Subject: 10CFR21 Reporting of Defects and Non-Compliance  
Thomas & Betts Printed Circuit Board P/N 41-01-251512

## 10CFR21 REPORTING OF DEFECTS AND NON-COMPLIANCE

COMPONENT: Thomas & Betts Printed Circuit Board P/N 41-01-251512

SYSTEM: Cyberex 20 kVA Model AC Power Supply

Figure 1, Modulation Index Control Card P/N: 41-01-251512

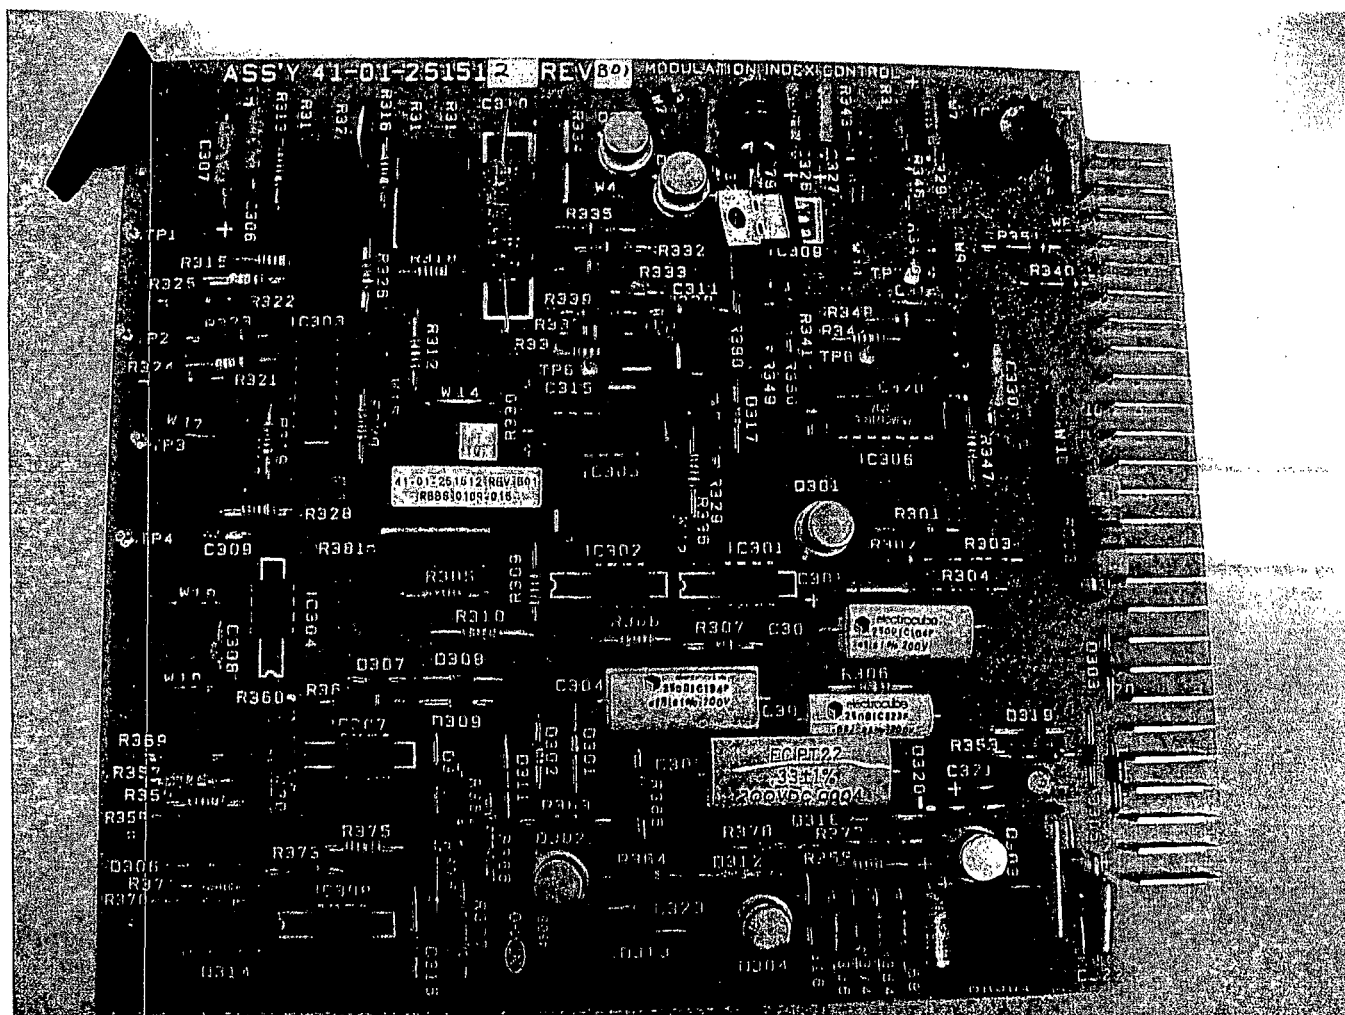
1. See figure 1 below for a picture of the Cyberex logic power supply board, p/n: 41-01-251512.
2. Inspect the board for the correct location of the resistor leads as shown in figure 2.
3. If resistor lead is installed as shown in figure 3 then notify UCI and an RMA will be issued for the repair.

Figure 2, Correct location of resistor leads

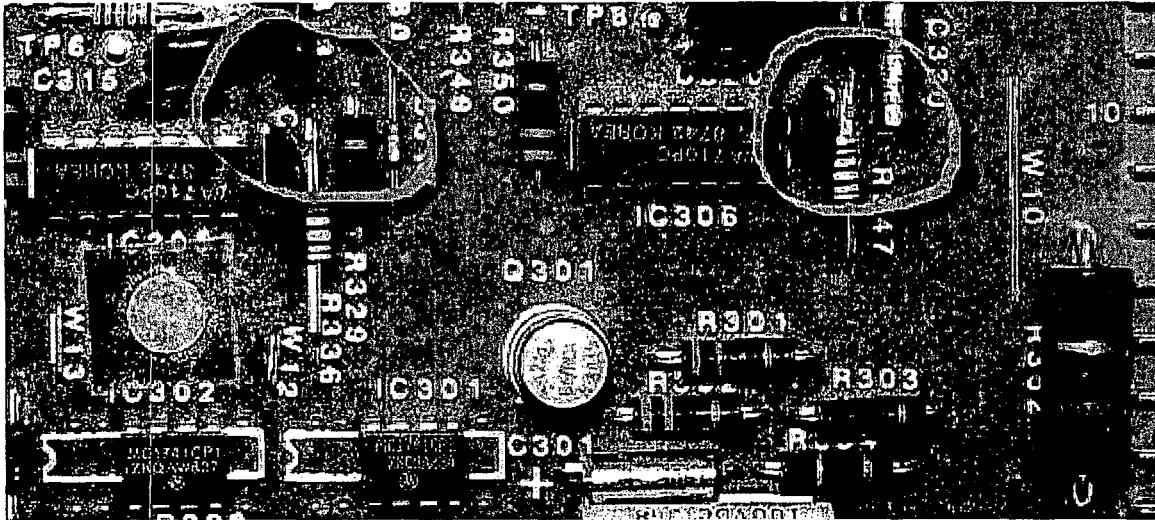
*The Inverter THD specification is < 5% and RMS voltage regulation is +/- 2%.  
The test results are within these parameters though the THD appears to be temperature sensitive and requires adjustment with any change in ambient temp. However, placement of resistors R336 and R347 in the "short" holes, as found on the 3 boards returned from the site, alters the operation of IC305 and IC306.*

*Consequently the circuits cannot function as designed. We believe the temperature sensitivity is a result of the incorrect resistors and are awaiting results of further testing from the site to confirm our suspicions.*

Pending any inspection (see Attachment 1 for instructions) performed by PSEG on field population, any defective units found will be reworked to original specifications and dedicated accordingly.
